Agenda Supplement

September 13, 2023
HDC Meeting

5. 424-428 West Bv (PID: 11907801)
HDCCMA-[2023-00283](#)
Wilmore
Brittany Lins & Collin Brown, Applicants

1 - Wilmore Neighborhood

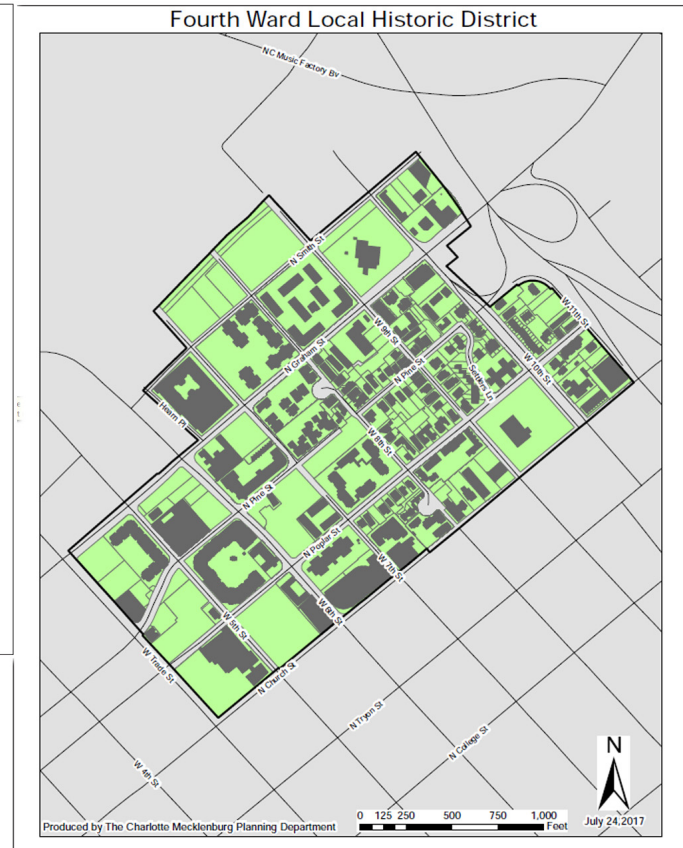
Historic Wilmore is not at all akin to Historic Fourth Ward, where there are several multi-story buildings. There is not a single building in Historic Wilmore that is more than three (3) stories.

2 - Context on W. Kingston Ave.

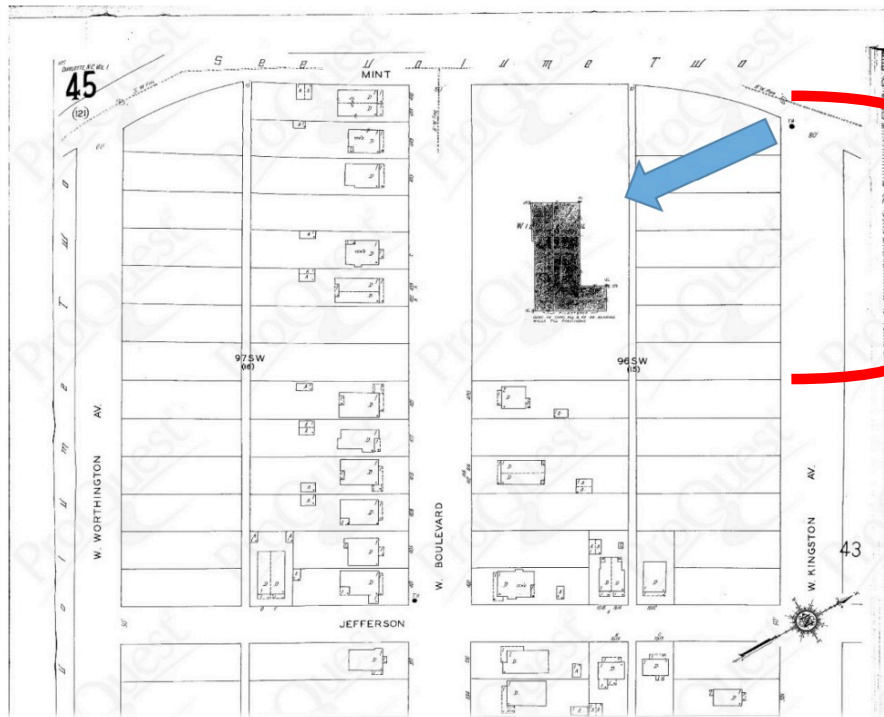
Before expansion into a paved parking lot, the Wilmore School lot on West Kingston Ave. was historically seven (7) separate parcels.

The massing and spacing of the proposed development needs to be broken down to fit the neighborhood context of the 1.5- and 2-story single-family homes on separate parcels (seven (7) to be specific).

3.1 - Height

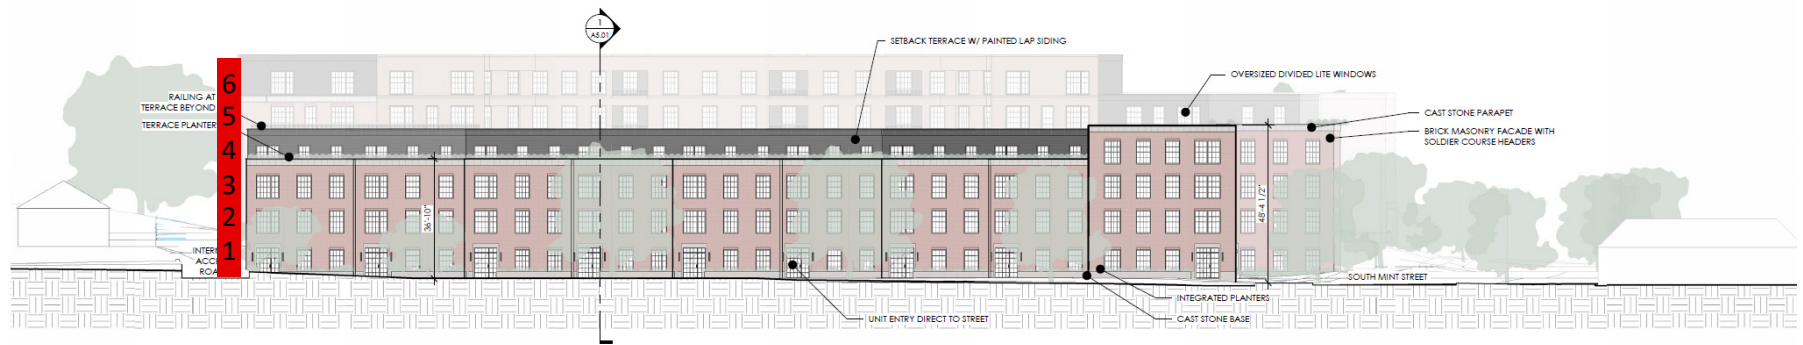
While the applicant alleges that “[t]he tallest 5 floor portion of the building (54-5’ above grade, max 65’ above average curb) will only be located at the center of the site and will have limited visibility from surrounding frontages”, this is not accurate. First, that tallest portion is actually 6 floors visually from the curb on each West Kingston Ave. and South Mint St. Second, the renderings provided by the applicant cherry-pick a select few angles at frontages where the proposed tallest portion may not be visible or only slightly visible. From the majority of angles (which are materially omitted by the applicant), the proposed tallest portion will be significantly visible, towering over adjacent 1.5 and 2-story single-family homes. The applicant needs to provide more renderings, at different sights/angles relative to the existing historic context (with height measurements), as well as with specific design details (window, doors, lighting, etc).

The tallest portion is actually 6 floors visually from the curb on each West Kingston Ave. and South Mint St.

3.2 - Height

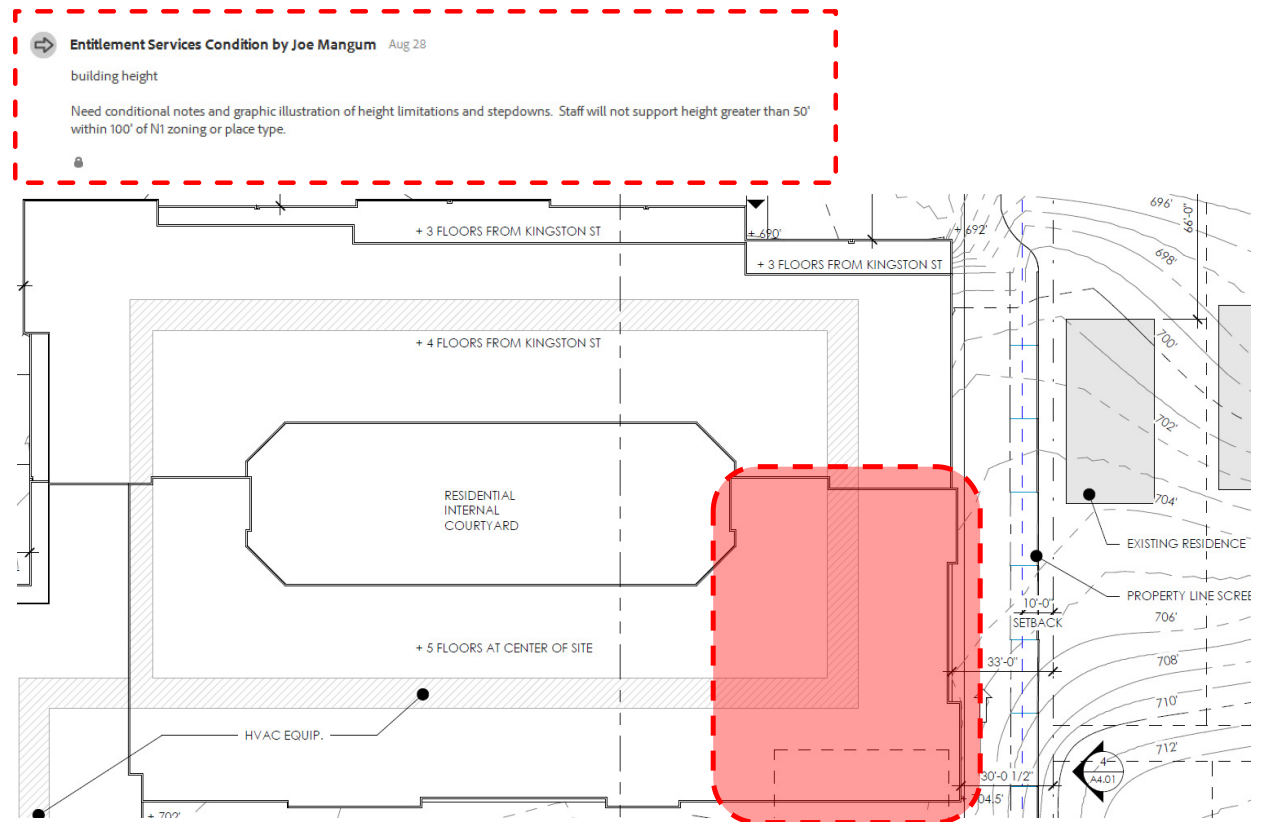
Proposed tallest tower will be significantly visible from different pedestrian viewpoints.

4.1 - Setback

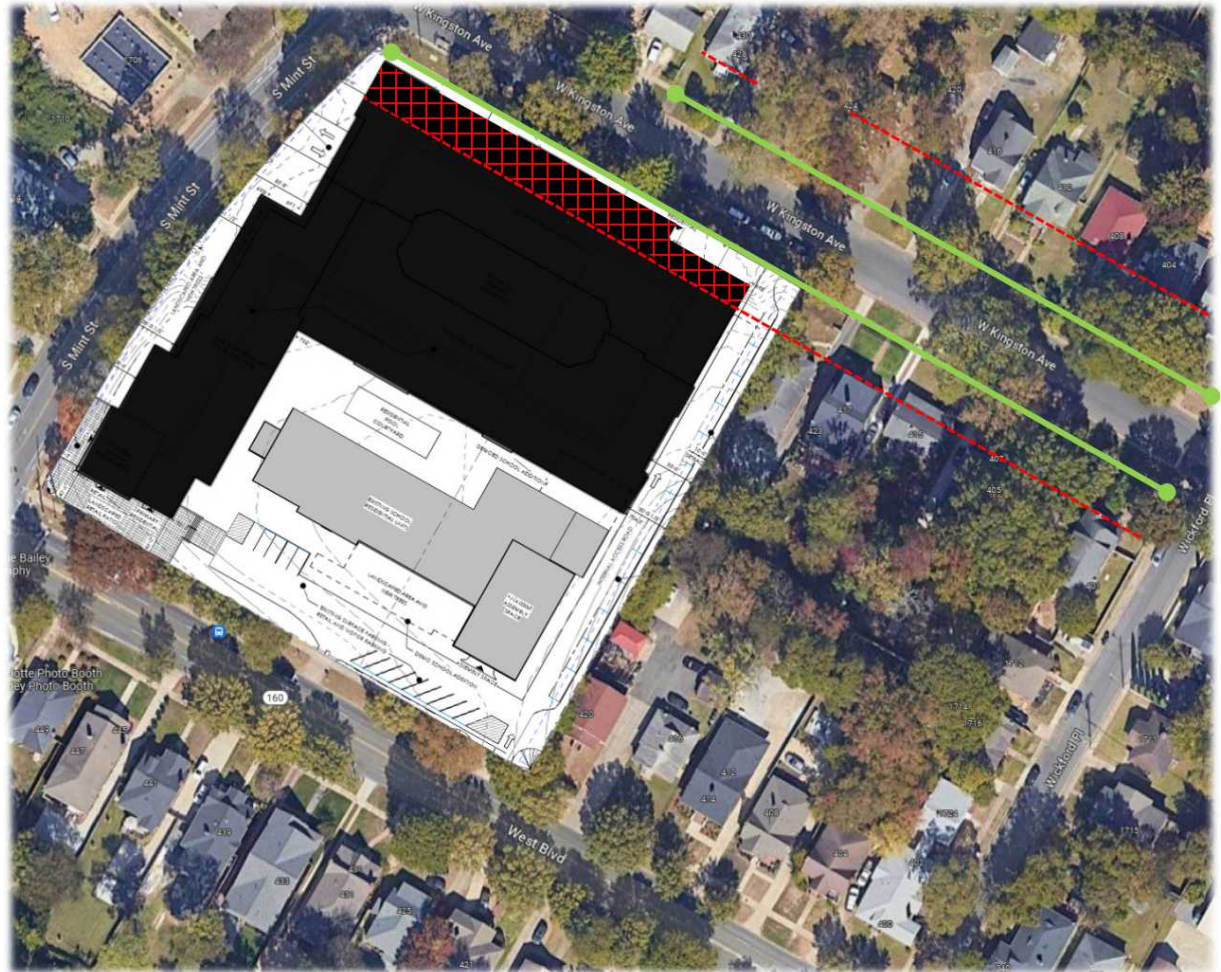
The setback for the proposed development on West Kingston Ave. must maintain and match the existing historic setback on the block — being relative to the homes that are oriented the same direction.

Area of Development that encroaches setback

4.2 - Setback

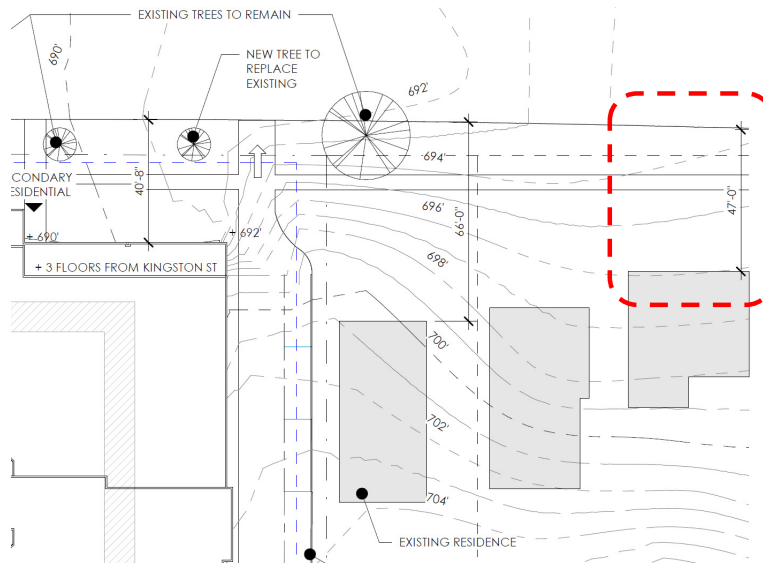
The applicant's referenced setback of 47'-0" for 415 West Kingston Ave. is not accurate, because it is not measured from the thermal wall; rather, the measurement wrongly includes the screened-in front porch. "Setback is the distance between the front thermal wall of the building and the property line or right-of-way boundary at the front of the lot." (Section 6.5 of the CHDDS).

4.3 - Setback

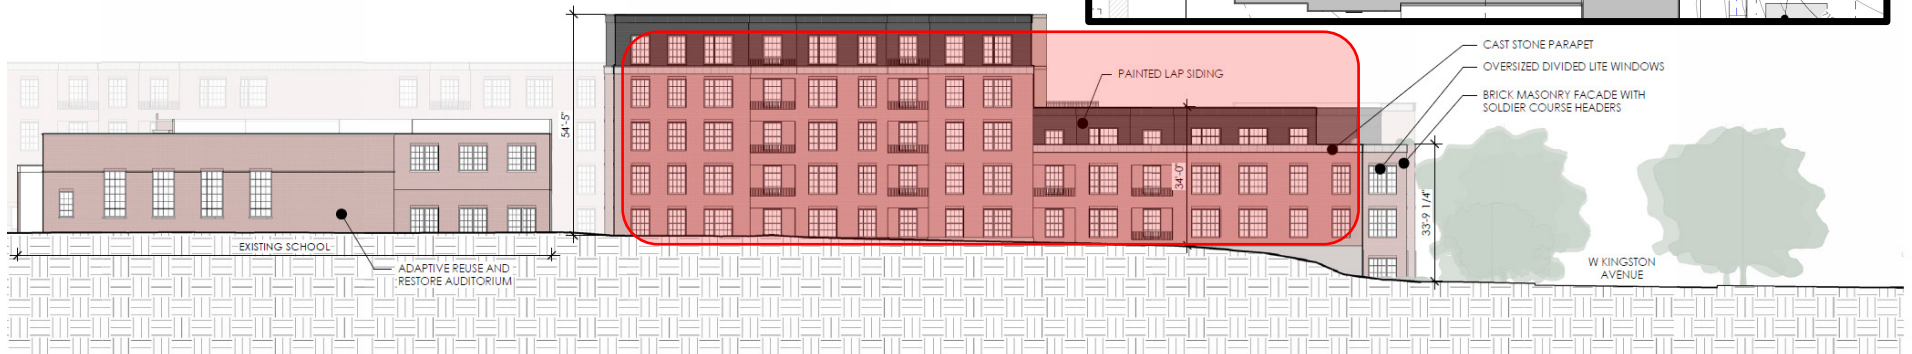
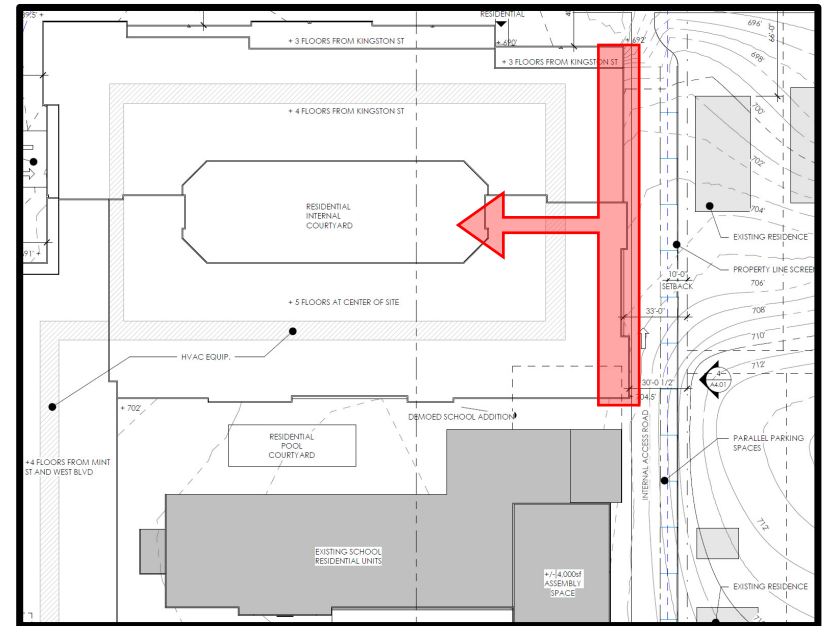
It is pertinent to note that each of the buildings referenced by the applicant for height context have large setbacks.

This is because large setbacks assist in reducing height, width, massing, spacing, etc.
